To:	Addendum #1 Hutchinson Square Park Improvements for Town of Summerville	From:	Josh Lilly, PE 4969 Centre Pointe Drive, Suite 200 North Charleston SC 29418-6952
File:	178420699	Date:	February 13, 2018

Reference: Addendum – Hutchinson Square Park Improvements – Road and Park Bid

The following changes have been made to the bidding and contract documents dated January 24th, 2018:

2 FOUNTAIN SECTION / ELEVATION

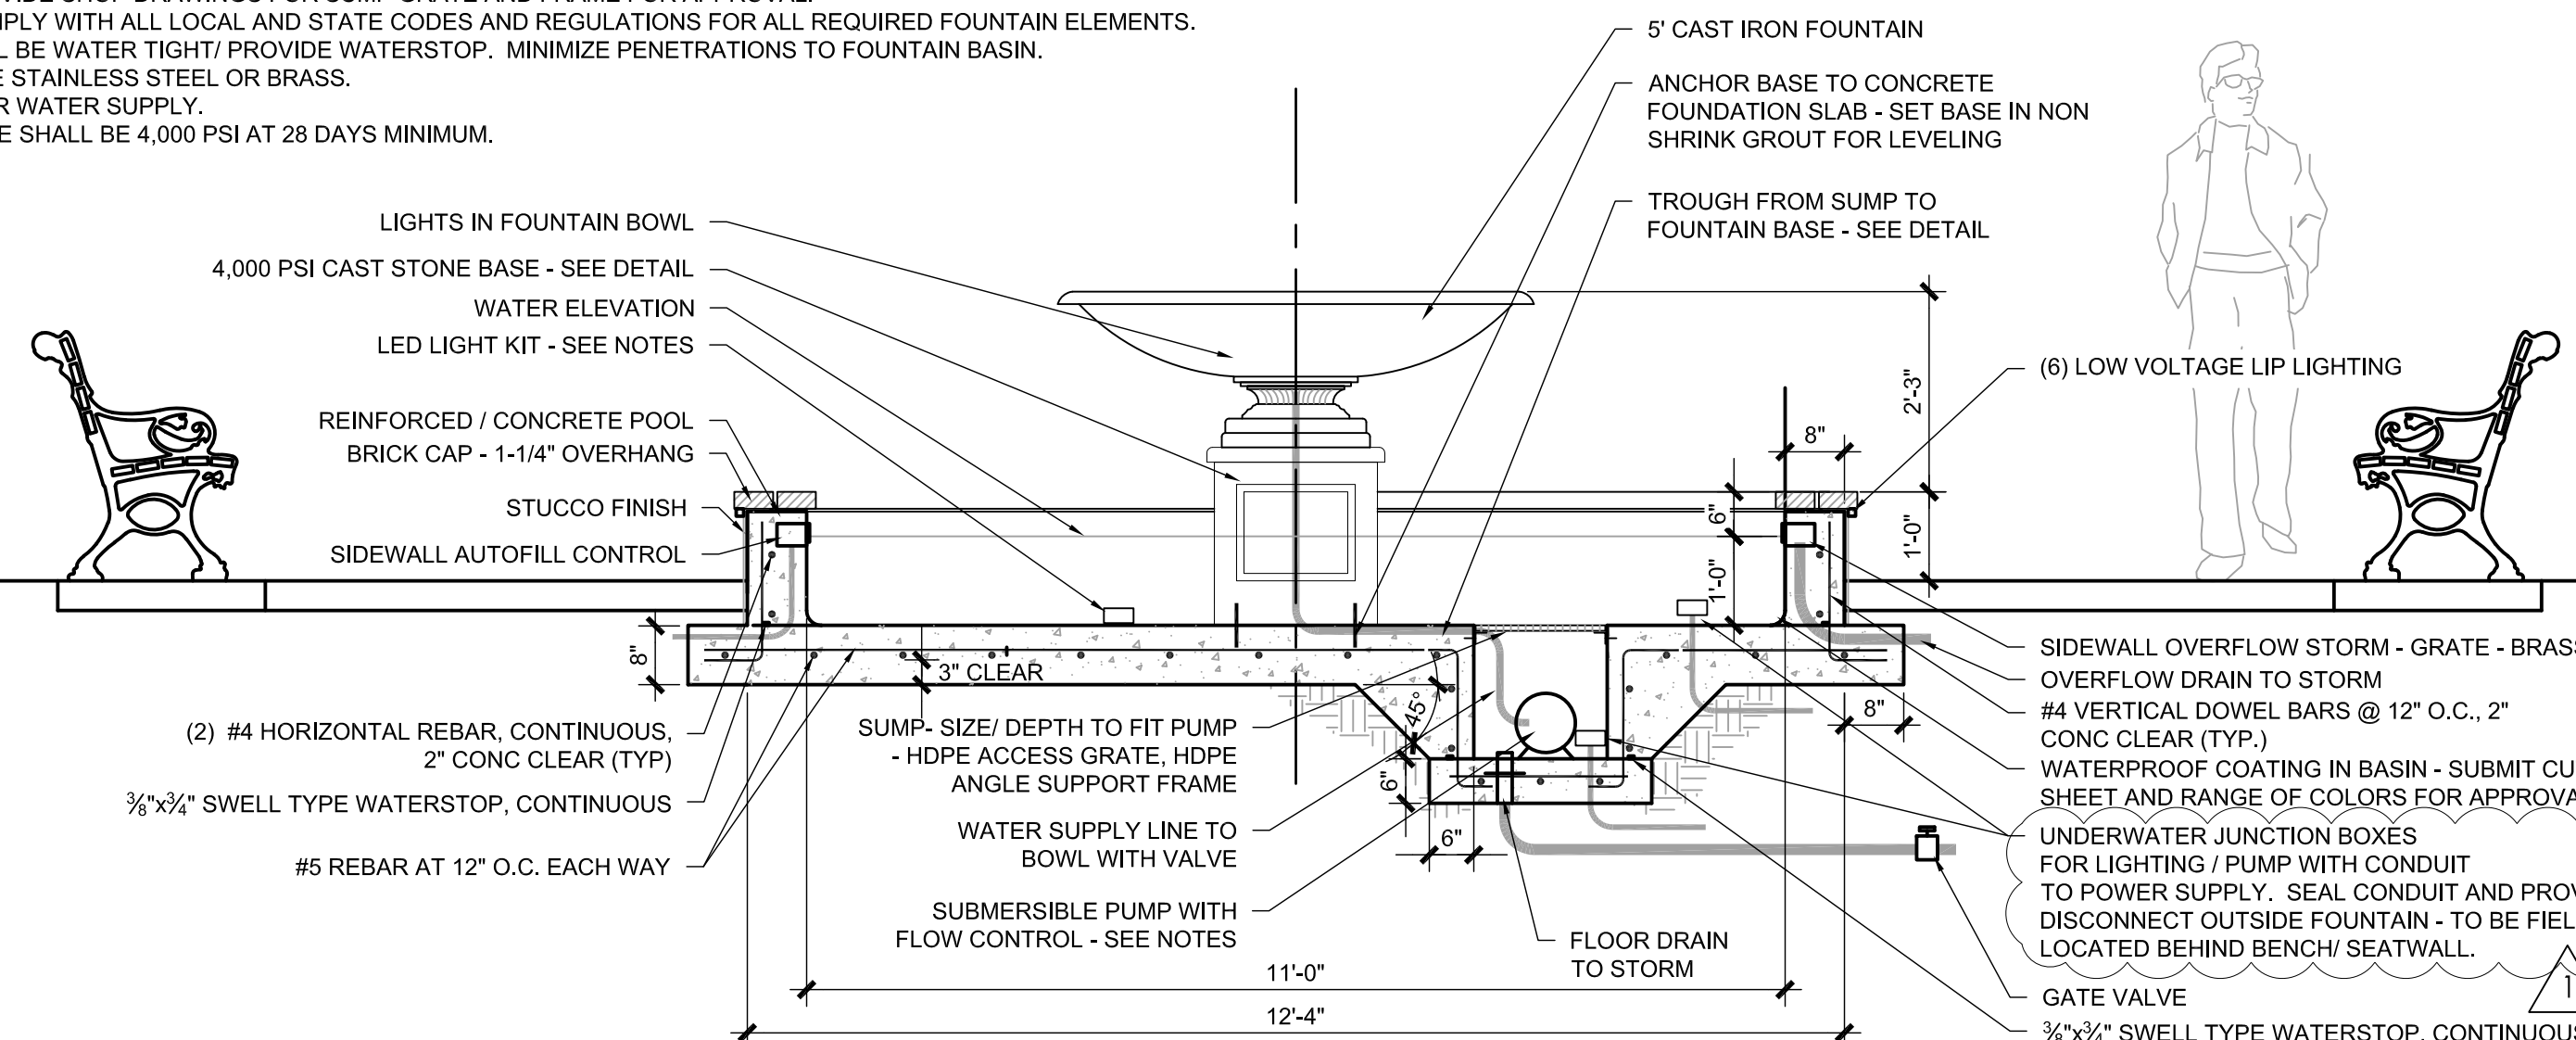
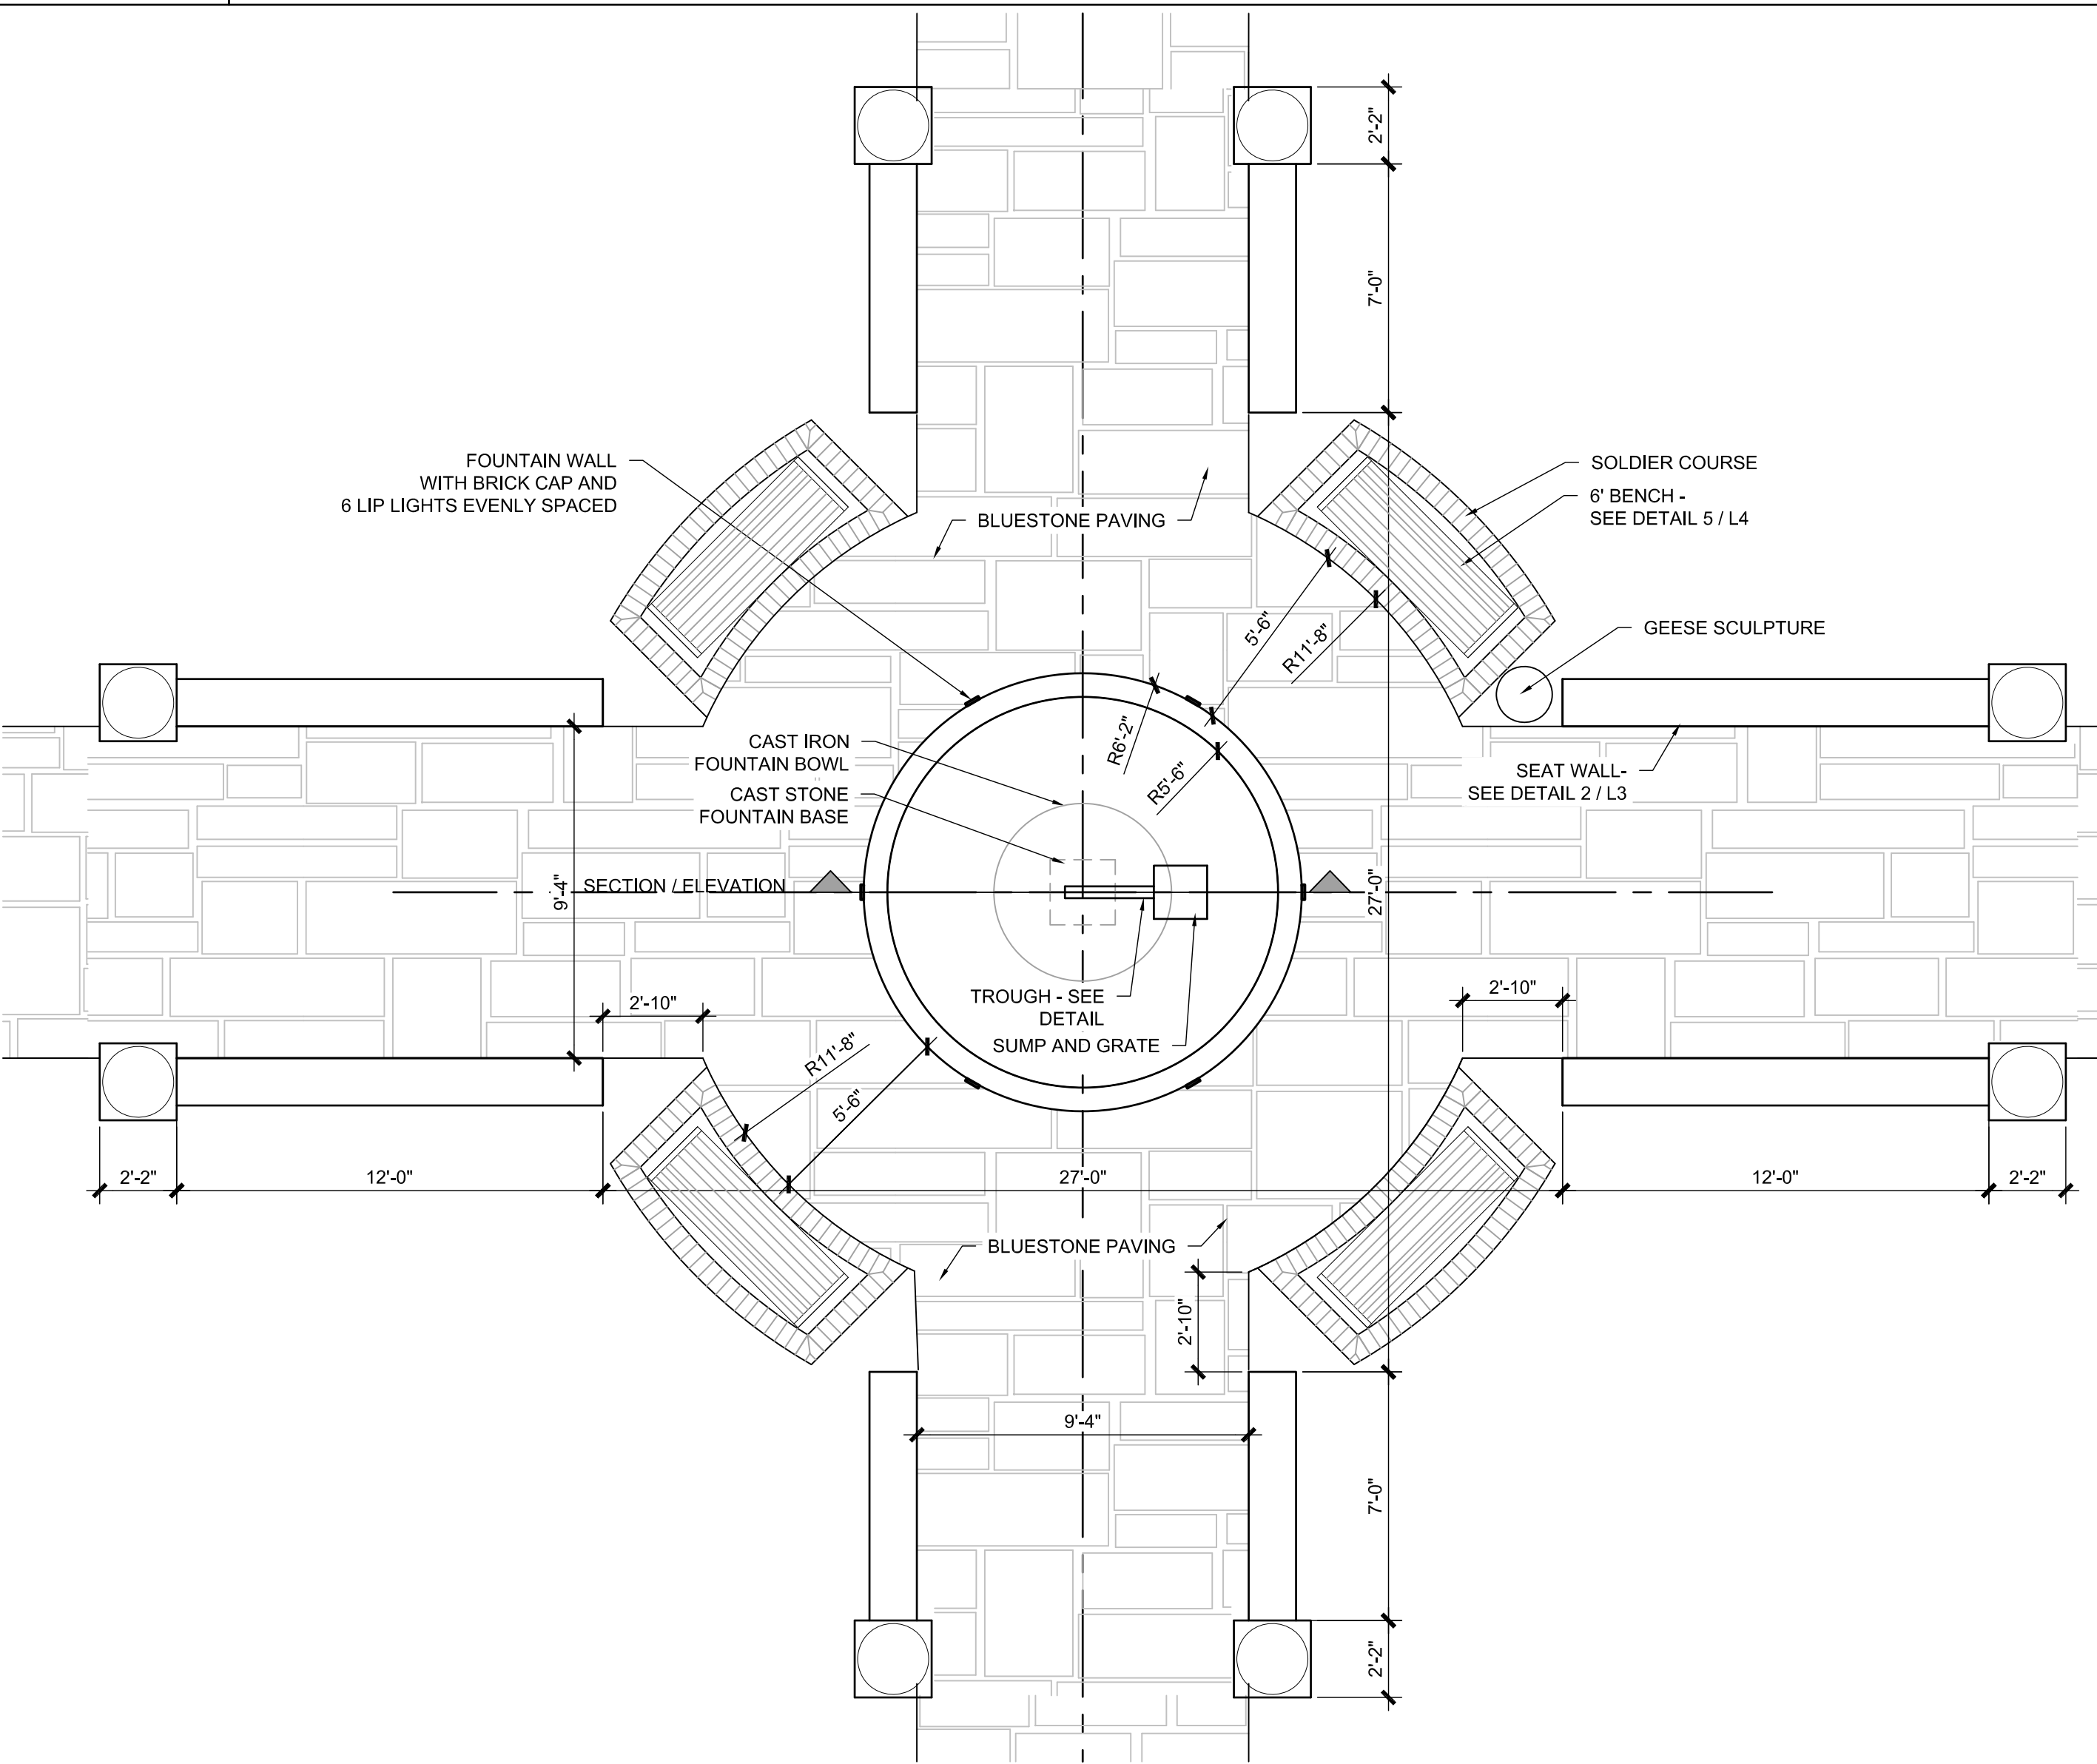
25. Fountain – What is the GPM, feet of head and voltage required for the submersible pump?

26. Fountain – What is the quantity of LED lights in the upper bowl and what are they to illuminate?

27. Fountain – What is the quantity of LED lights in the lower pool and are they to illuminate the upper weir edge lip only?

28. Fountain – What is the wattage desired for the LED lights?

A – The design intent of the fountain is to have a constant unbroken ribbon of water over the lip of the fountain bowl. The estimated GPM required for this is 1,200 gallons per hour **per**

linear foot of the fountain bowl edge. The approximate vertical feet of head to the base of the bowl is 4'. Feet of head along the piping route to the base of the fountain is approximately 6'. Contractor to coordinate with pump manufacturer to size pump based on the fountain design intent. The park electrical can accommodate 120V or 240V power for the pump if required.

A – Two lights are proposed for the upper bowl to provide a glow to the water surface. Light placement will be field adjusted for desired effect.

A - Three lights are proposed for the lower pool to illuminate the ribbon of water and underside / wier of the bowl. Light placement will be field adjusted for desired effect.

A- 7 watt – 450 lumen LED lights should be sufficient to illuminate the fountain.
